SERVICE BULLETIN

MITSUBISHI MOTORS

PURPOSE : CORRECTION	ISSUE NO. : MSB-15EXL52_54_90-501	DATE : 2015-09-10
SUBJECT : Error in writing and omission about the inspection procedure and the wiring diagram of the front seat belt switch		<DESTINATION/MODEL> (As per attached sheet 1) <M/Y> 09-15
GROUP : Gr:52(Interior & SRS Airbag)/Gr:54(Chassis electrical)/Gr:90(Circuit diagram)		OUTLANDER SPORT/ASX/LANCER/LANCER SPORTBACK/4008/C4 AIRCROSS

INSPECTION OF SEAT BELT SWITCH FOR CONTINUITY

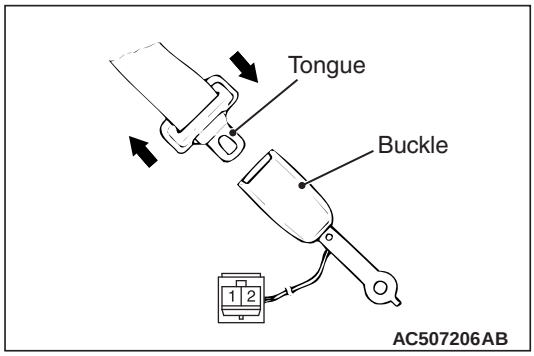
(DRIVER'S SIDE) <Added>

<Added>

Item		Terminal number	Normal conditions
Not seated	Fastened seat belt	1 – 2	No continuity
	Unfastened seat belt		
Seated	Fastened seat belt		
	Unfastened seat belt		Continuity exists (100 Ω or less)

- *When the continuity exist with the seat belt fastened, replace the inner seat belt.*
- *When the continuity does not exist while the front passenger is seated with the seat belt unfastened, replace the inner seat belt.*
- *When the continuity exists while the front passenger is NOT seated with the seat belt unfastened, check the seat belt reminder switch.*

SEAT BELT SWITCH CONTINUITY CHECK (PASSENGER'S SIDE)

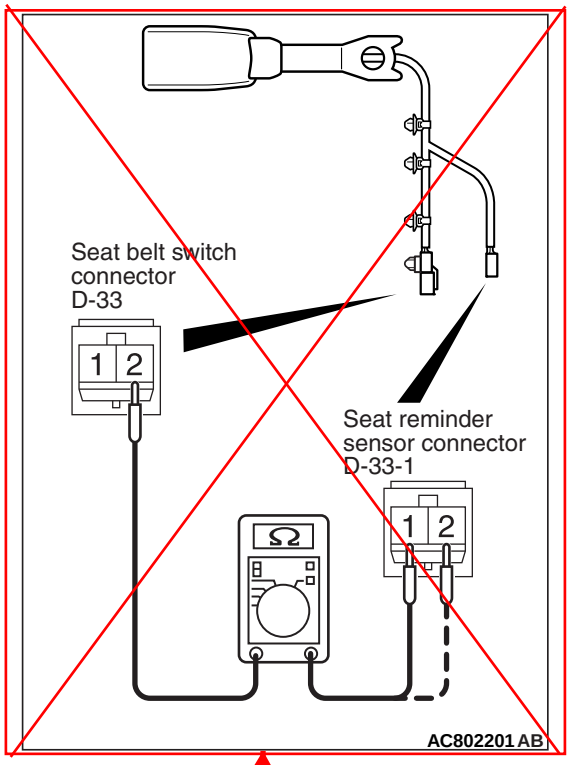
<Incorrect>

Item	Tester connection	Specified condition
Fastened seat belt	Connector D-33-1 (terminal No.2) – D-33 (terminal No.2)	Open circuit
Unfastened seat belt		Continuity exists (Less than 2 Ω)

<Incorrect>

SEAT BELT REMINDER SENSOR CONNECTOR CHECK (PASSENGER'S SIDE)

Item	Tester connection	Specified condition
Fastened seat belt	Connector D-33-1 (terminal No.1) – D-33-1 (terminal No.2)	Open circuit
Unfastened seat belt		Continuity exists (Less than 2 Ω)

SEAT BELT REMINDER SENSOR CONNECTOR CHECK (PASSENGER'S SIDE)

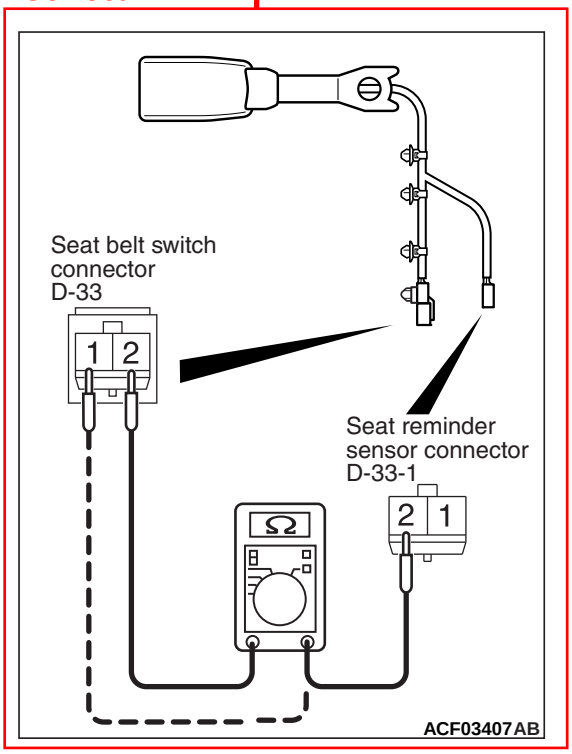
<Correct>

Item	Tester connection	Specified condition
Fastened seat belt	Connector D-33 (terminal No.1) – D-33 (terminal No.2)	Open circuit
Unfastened seat belt		Continuity exists (Less than 2 Ω)

- *Put a weight on the cushion before inspection.*
- *Connect the seat belt switch connector with the seat belt reminder sensor connector before inspection.*
